**NUCLEAR REGULATORY COMMISSION**

Title: Advisory Committee on Reactor Safeguards  
528th Meeting

Date: Wednesday, December 7, 2005

Figure 3: Dryer Monitoring & Test Plateaus

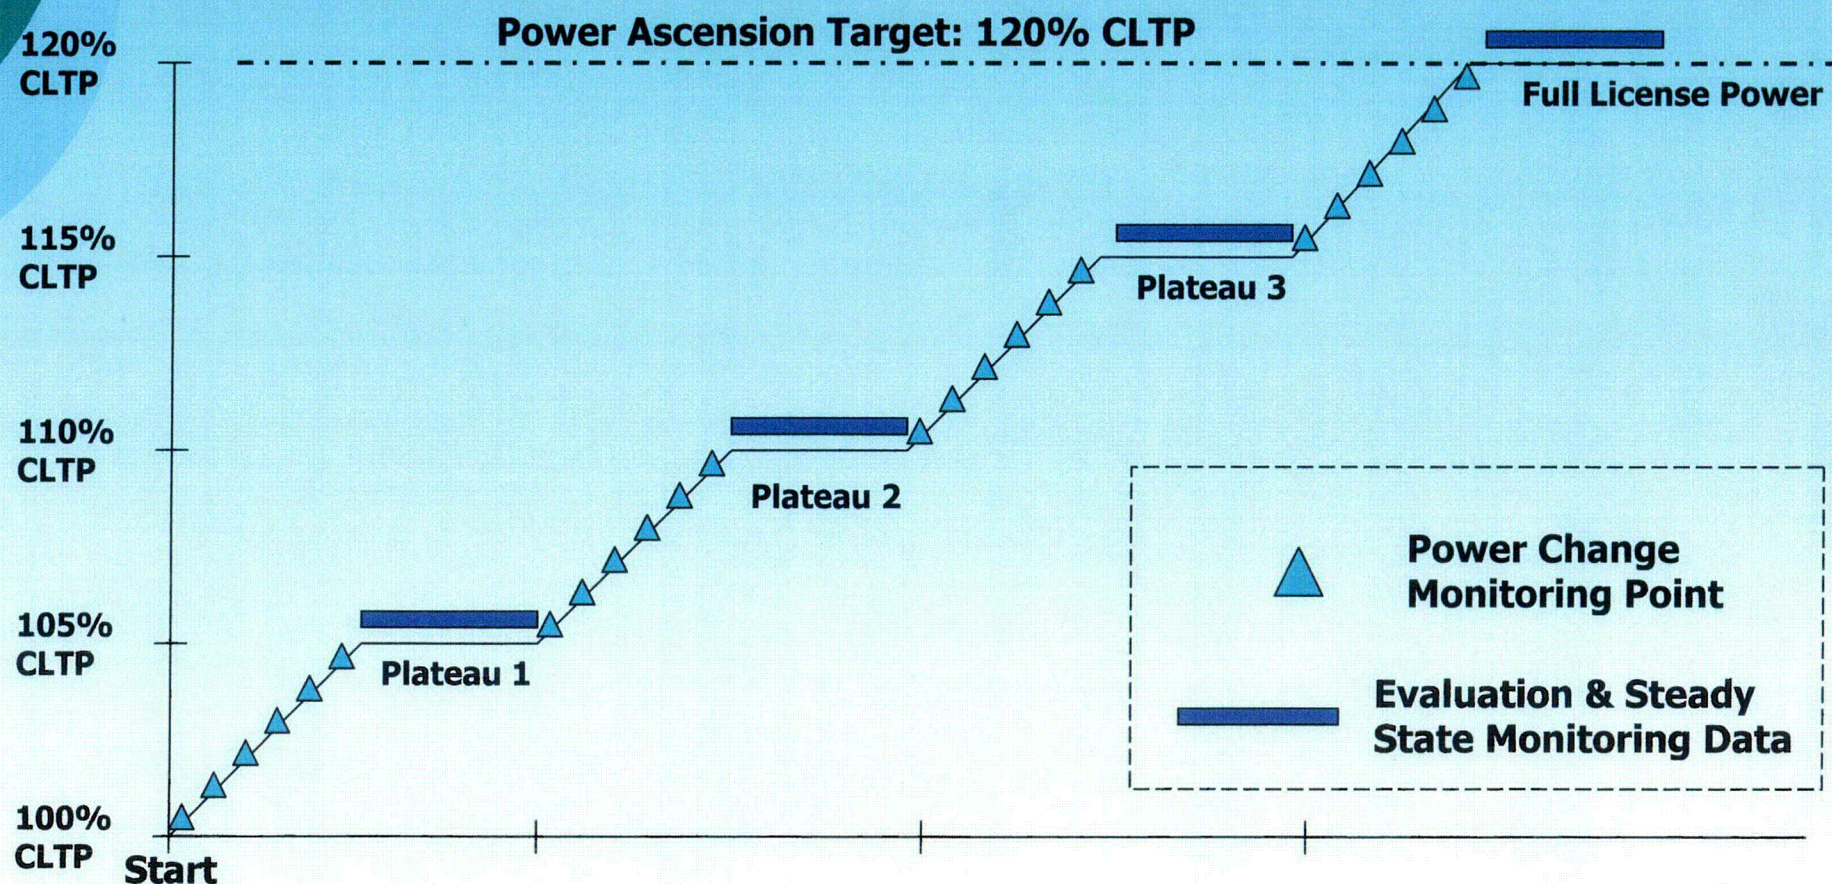
1 condition each test plateau has a 24-hour minimum hold  
2 time to collect strain gauge, accelerometer, and plant  
3 data, perform inspections, and evaluate results.

## Entergy's Risk Evaluation (continued)

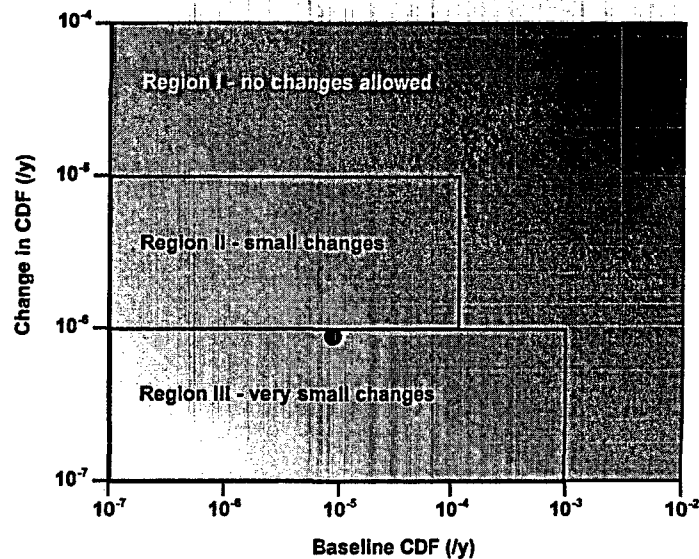
6 Okay. The second thing and perhaps more  
7 puzzling here is the difference in the presumed  
8 probability of preexisting leakage into the  
9 containment. You'll see that Entergy's estimate is  
10 almost two orders of magnitude below mine, and so I  
11 had to question. In fact, that was the basis of one  
12 of the RAIs that I had asked why do you get this large  
13 number.

15 MR. STUTZKE: Well, I want to talk about  
16 it, I guess, in terms of the plot on the next page.  
17 The fact is that they generate a change in CDF due to  
18 the over pressure credit assumption alone that's about  
19 an order of magnitude higher than mine. When I add  
20 that change in core damage frequency to the change in  
21 core damage frequency due to other impacts of the  
22 proposed EPU, I get a total change of about 90 minus  
23 seven per year. Okay?

Figure 4.2 LOCA – Long Term (1.5 wt. % Containment Leakage & 100% Spray Efficiency)

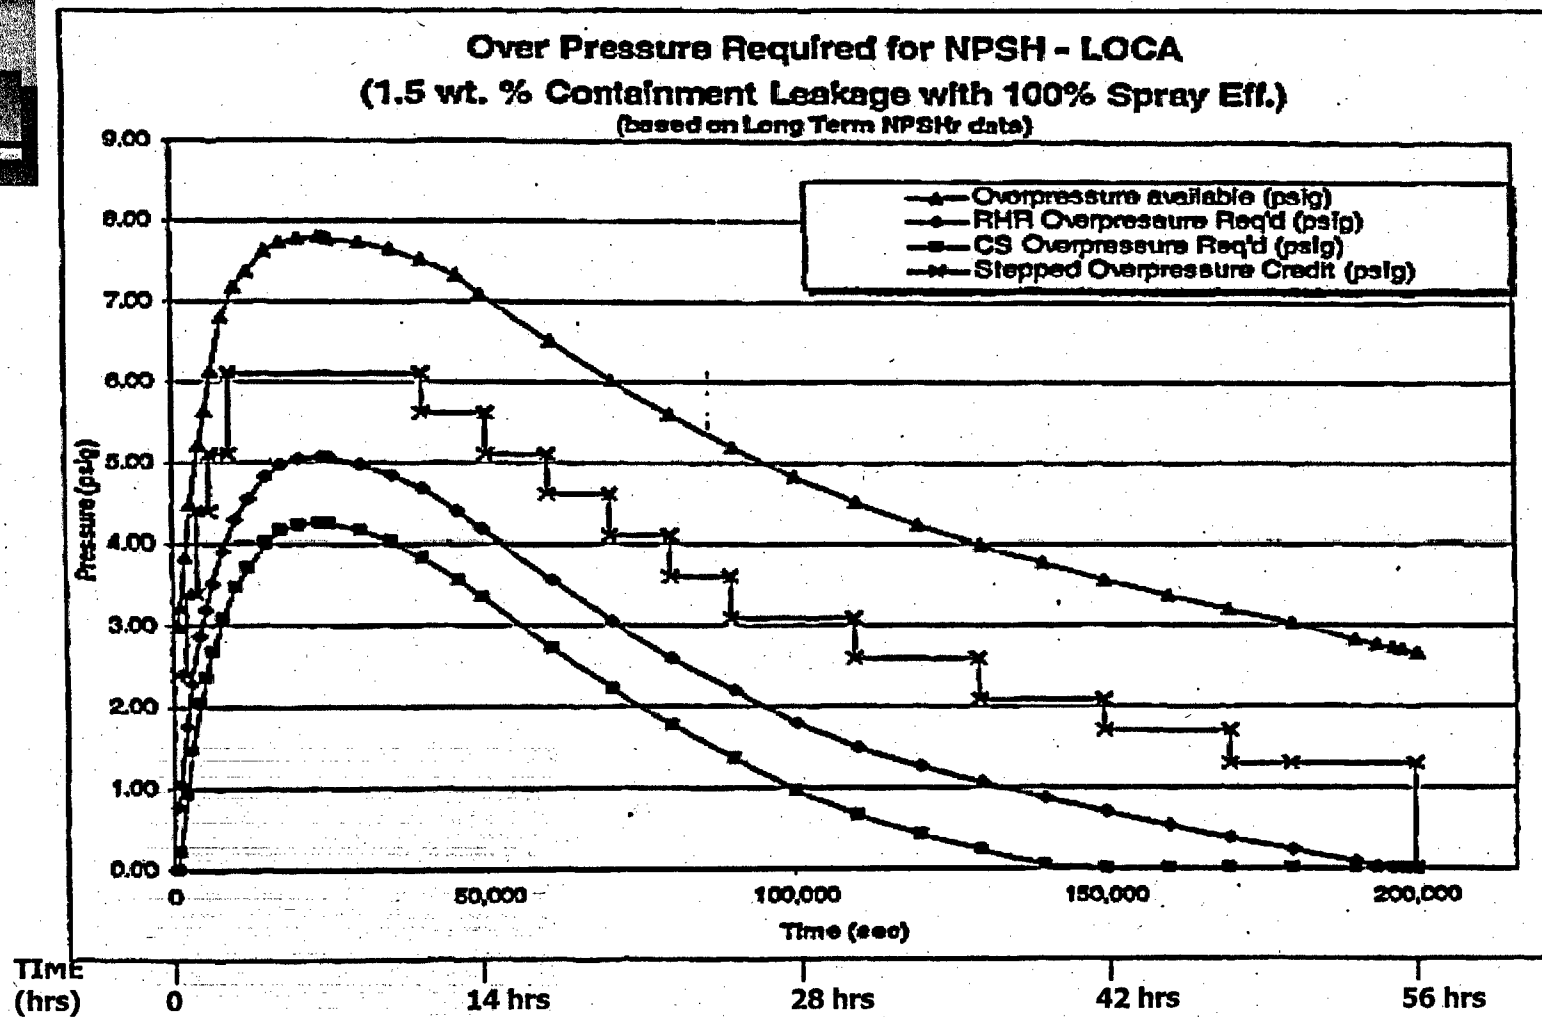
19 Let me just flip back for a minute. On  
20 the LOCA curve they only showed eight pounds, seven  
21 and change of pressure available.

Figure 4.3-1

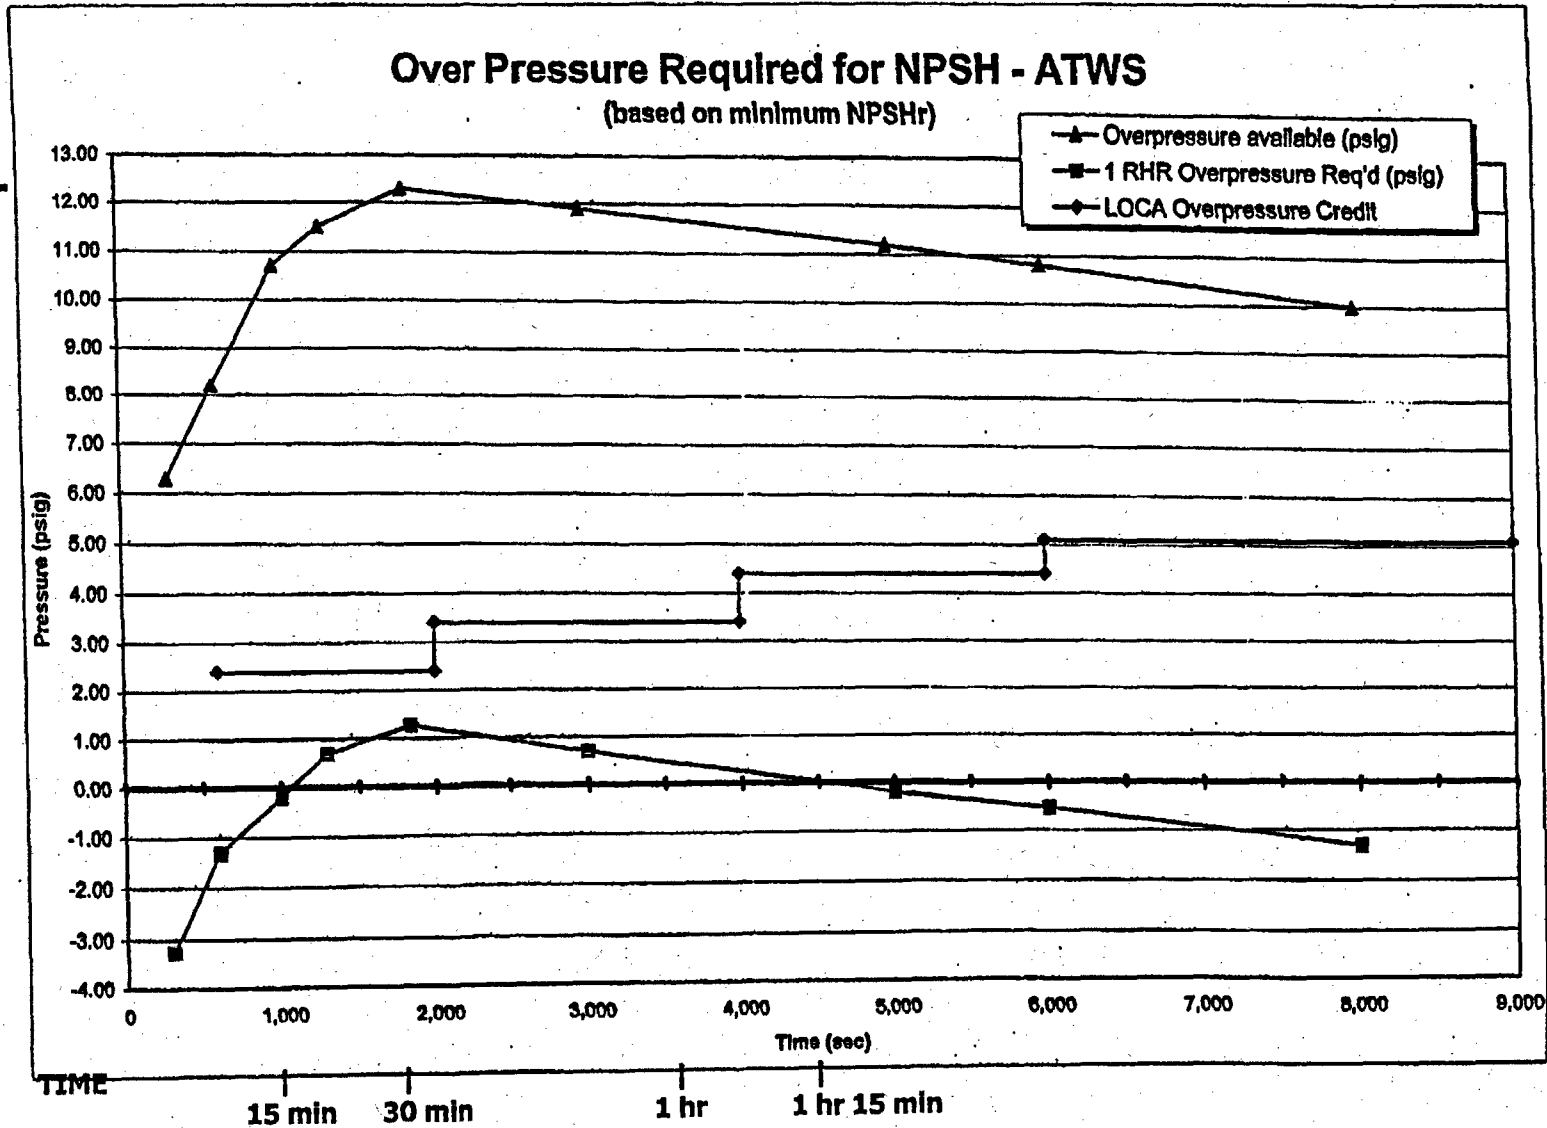
8 The ATWS NPSH evaluation deserves a few  
9 more questions, I think. Most of what has been  
10 focused on is the LOCA NPSH evaluation. Let me just  
11 go to the next curve. This is the curve that the  
12 licensee provided for the ATWS, and let's just take a  
13 minute with it.

14 You can see at the bottom I put a time  
15 scale on the bottom. They need overpressure credit  
16 starting at 15 minutes, and they don't need it again  
17 after an hour and 15 minutes. It's an ATWS. They  
18 have 12 pounds pressure that they show.

22 So now flipping back to the ATWS curve,  
23 you ask yourself a question at ATWS. ATWS has as much  
24 energy in it as a LOCA, and the way that ATWS develops  
25 pressure is a little bit different than a LOCA, but

6 And the answer is because these are  
7 nominal values. These are not conservative values,  
8 and so what that means is that in Mr. Stutzke's  
9 presentation, using realistic assumptions to estimate,  
10 evaluate available NPSH, no containment overpressure  
11 credit is necessary. I don't believe that's true  
12 because I believe that these are realistic  
13 assumptions. I believe the nominal assumptions in  
14 ATWS show that overpressure is available.

1           And my only point in showing this is this,  
2           that I'm not sure that the ATWS analysis meets the  
3           proposed Reg. Guide 182 change that the committee  
4           didn't accept because that proposed Reg. Guide 182  
5           suggested that for overpressure they should do  
6           conservative calculations, maximize the temperature,  
7           minimize the pressure, but with ATWS they haven't done  
8           it, and if ATWS was done that way, you don't really  
9           know where it's going to come out compared to the  
10          LOCA.

18 We did look at the ATWS calculation. I  
19 haven't looked at it lately, but Mr. Sherman is  
20 correct that the ATWS is supposed to be or can be  
21 analyzed with nominal realistic values, but Vermont  
22 Yankee did use some conservative assumptions. They  
23 used the maximum flow rate for the pump. They  
24 considered that the debris from the LOCA was on the  
25 ECCS strainers even though the only debris that would

17 MR. LOBEL: Well, I was aware of the ATWS  
18 situation. I was debating whether to put that in the  
19 presentation. I was trying to keep the presentation  
20 focused, and I don't believe that because of the  
21 conservatisms that we've just mentioned that if you  
22 took those conservatisms out that it would change the  
23 conclusion, you wouldn't need containment pressure.
